DEPARTMENT OF TRANSPORTATION

RE: Preliminary Plan No. 120250050
2811 14th Street NE Gospel Hall, Inc. Church
Preliminary Plan Letter

We have completed our review of the revised preliminary plan uploaded to eplans on December 18, 2024. A previous version of the plans was reviewed by the Development Review Committee at its November 19, 2024, meeting. This plan is tentatively scheduled for the February 27, 2025, Planning Board meeting. We recommend approval of the plans subject to the following comments:

SIGHT DISTANCE PROFILES
SCALE: HORZ. = 1" = 50'
VERT. = 1" = 5'

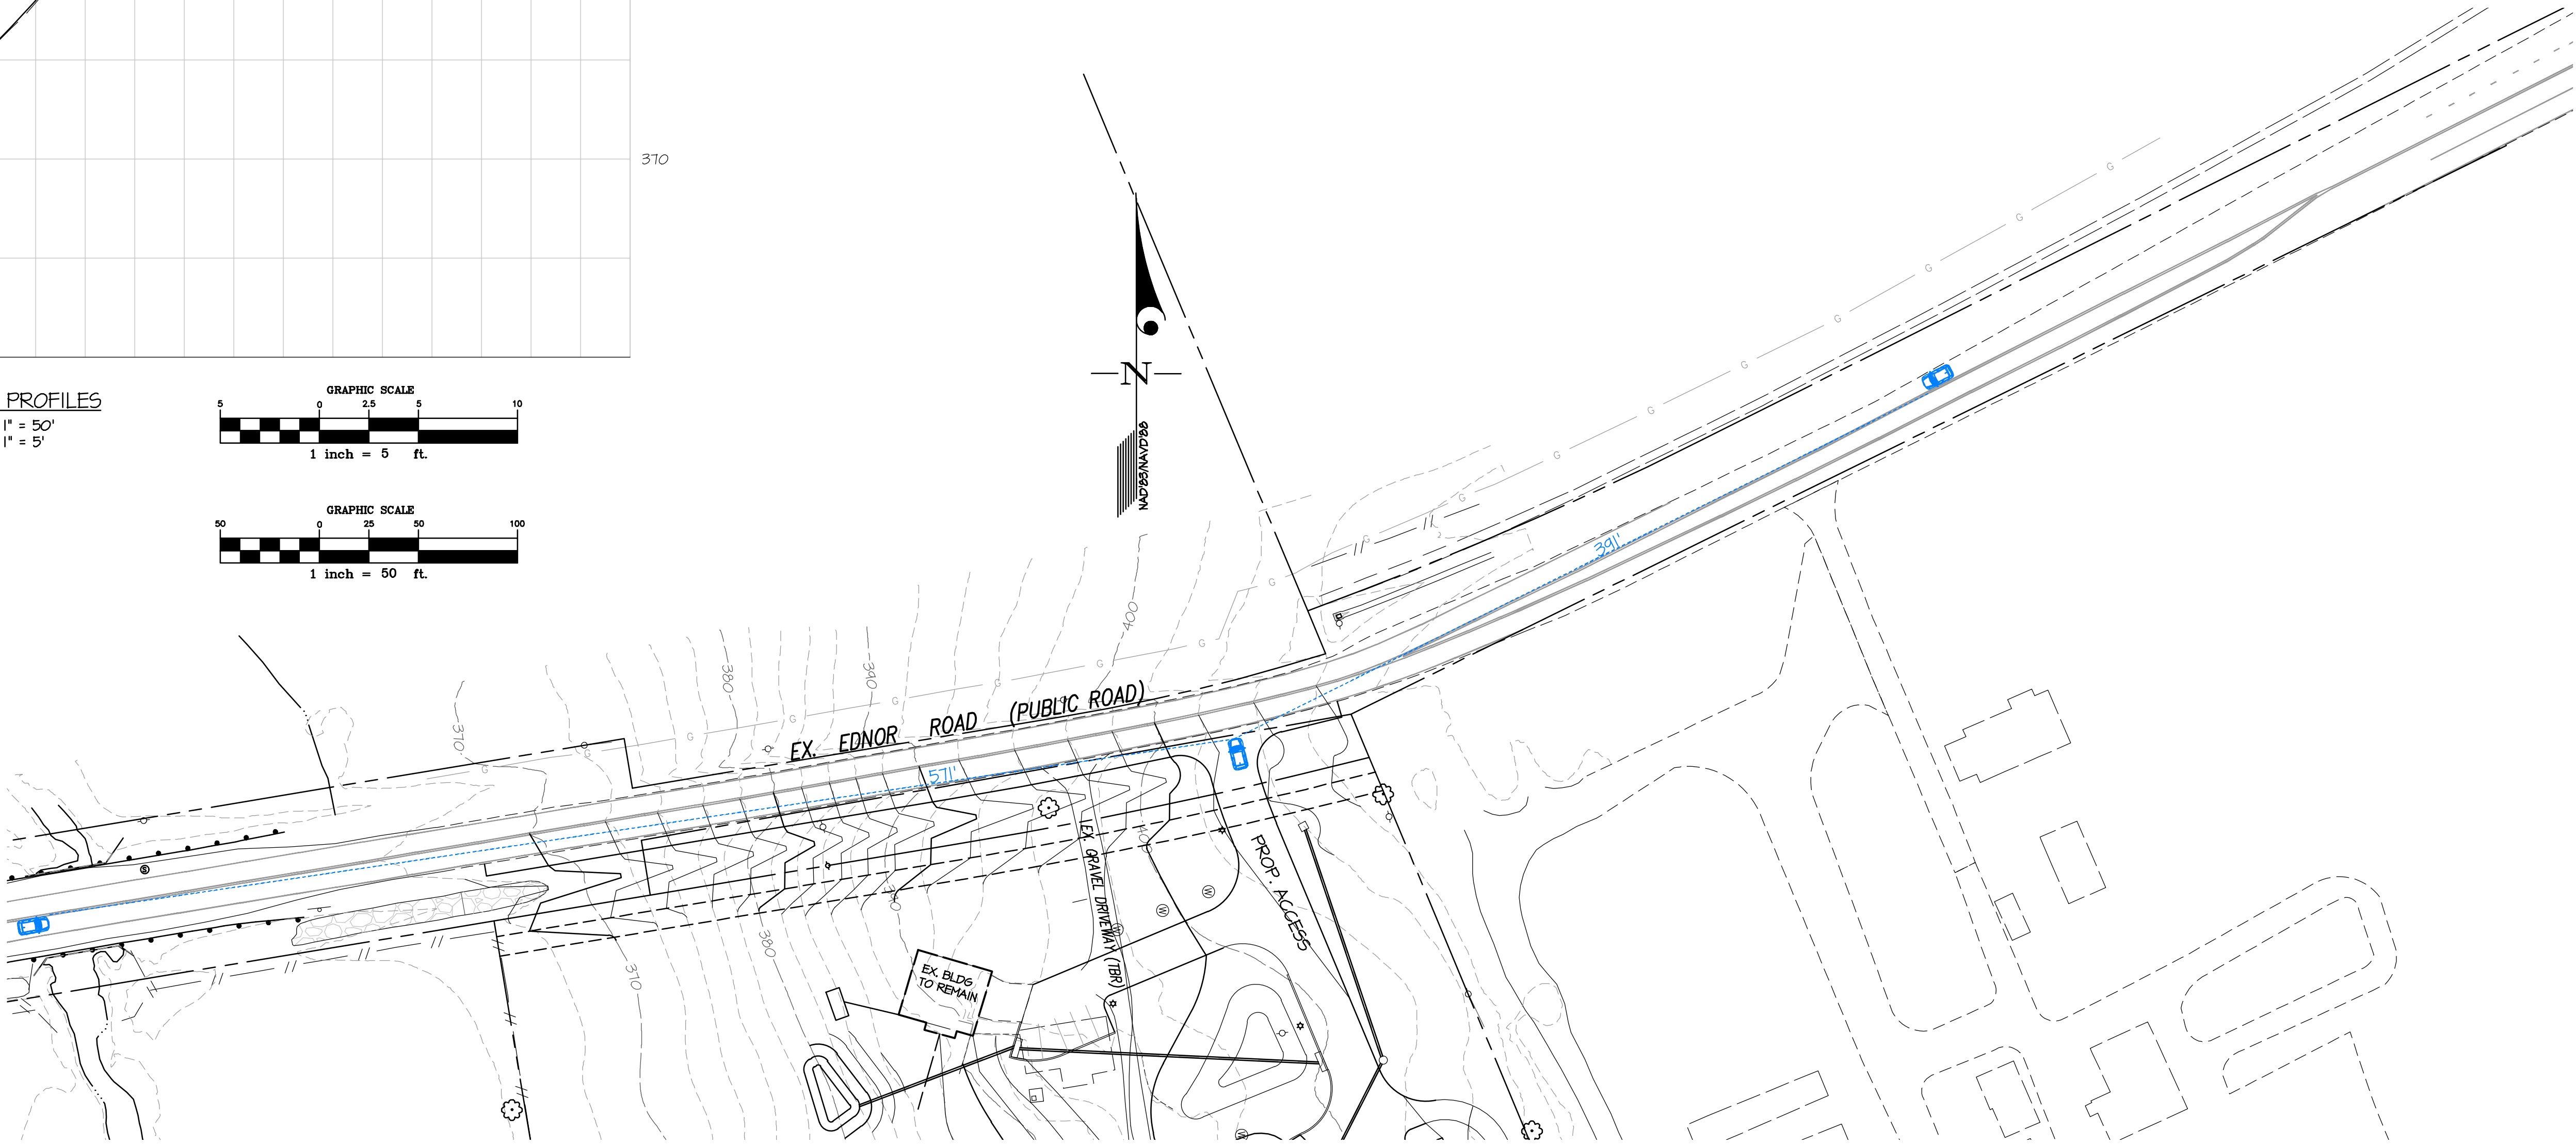
- b. The crosswalk must be operating and installed prior to the occupancy permit of the building.
5. **Sight Distance:** A copy of the accepted Sight Distances Evaluation certification form is enclosed for your information and reference. The applicant is responsible to ensure sight distance which should be clear of any existing or proposed obstructions within the line of sight (tree trimming and/or removal, relocation of existing utility pole, removal of street parking etc.) to achieve a minimum sight distance in each direction.

FIRE ACCESS PLAN

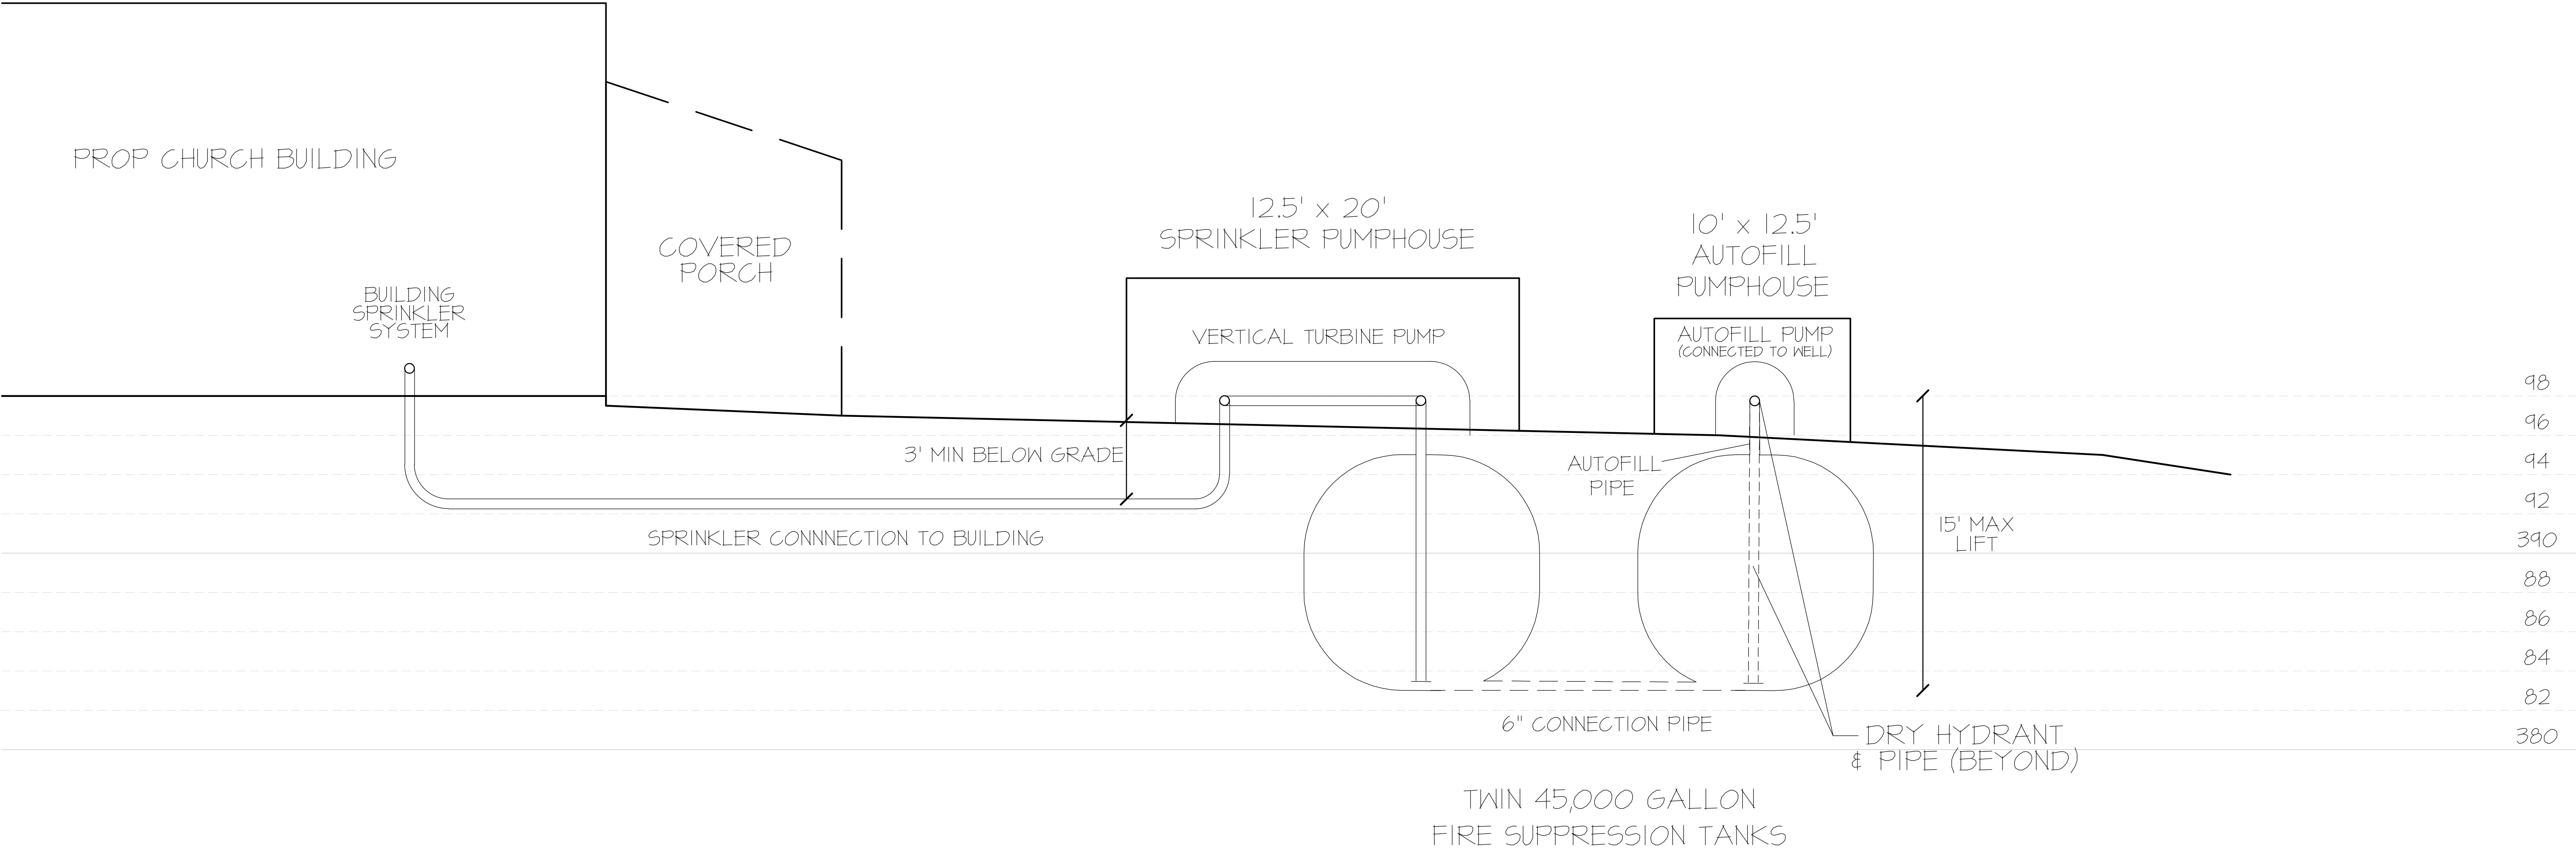
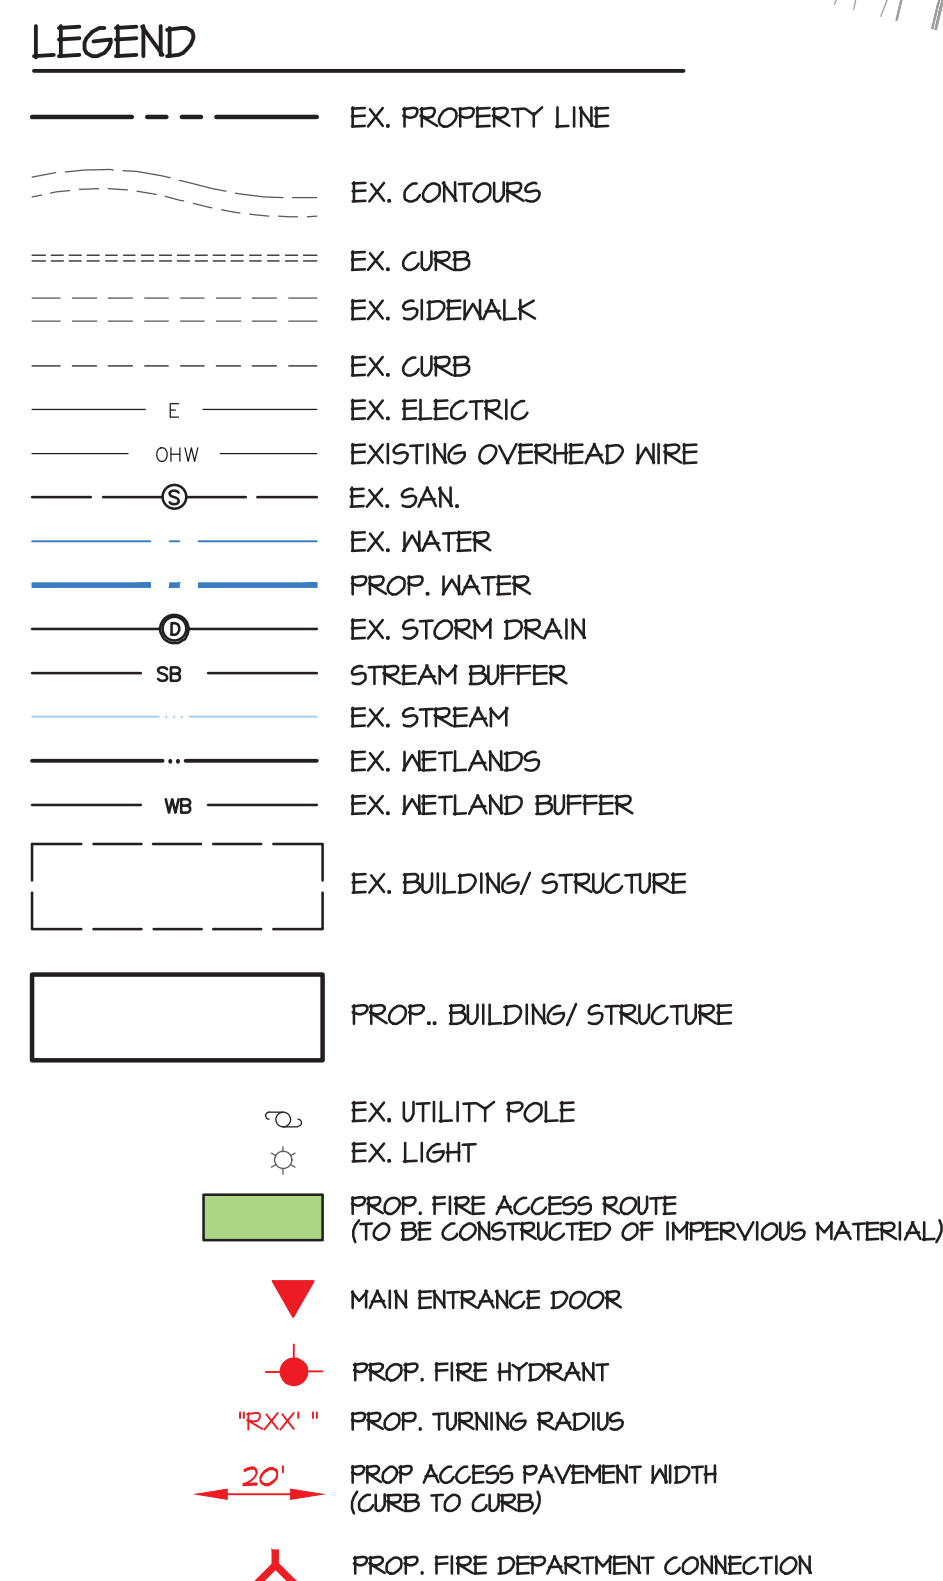
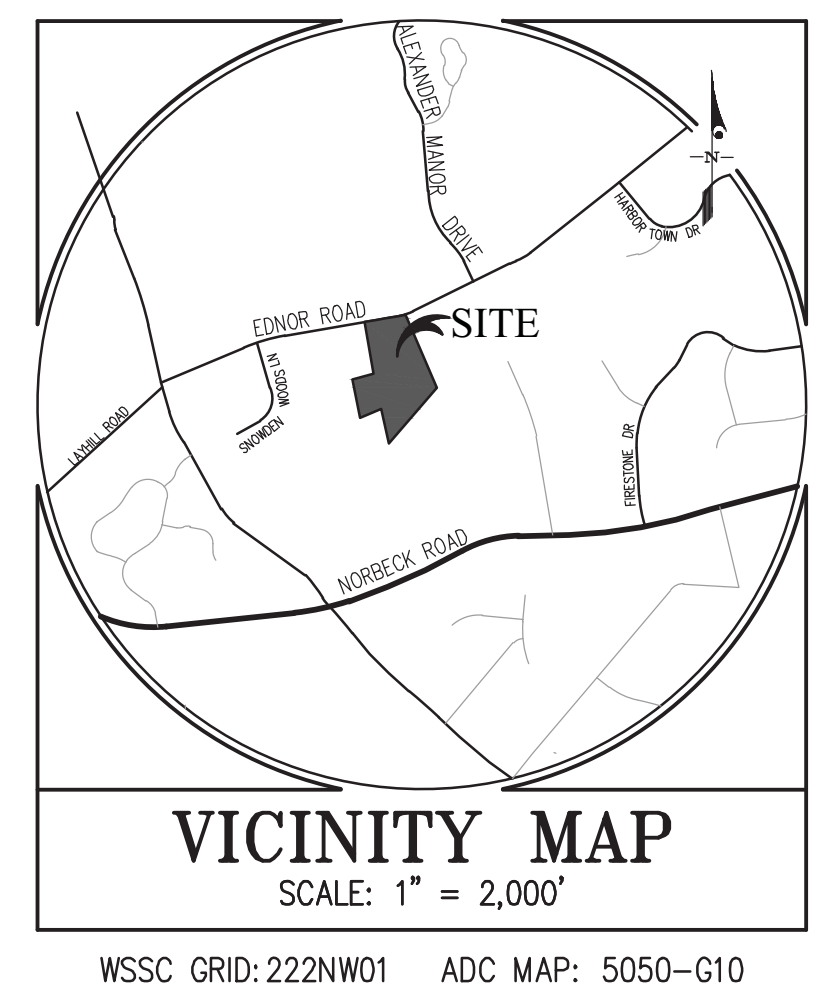
1. Review based only upon information contained on the plan submitted **17-Apr-25** .Review and approval does not cover unsatisfactory installation resulting from errors, omissions, or failure to clearly indicate conditions on this plan.
2. Correction of unsatisfactory installation will be required upon inspection and service of notice of violation to a party responsible for the property.

***** Submit to DPS Commercial Building for fire protection system permit prior to cistern construction. Cistern and dry hydrant installation required prior to occupancy. *****

*****5/20/2025 Update approval package with sealed water supply calculation report *****
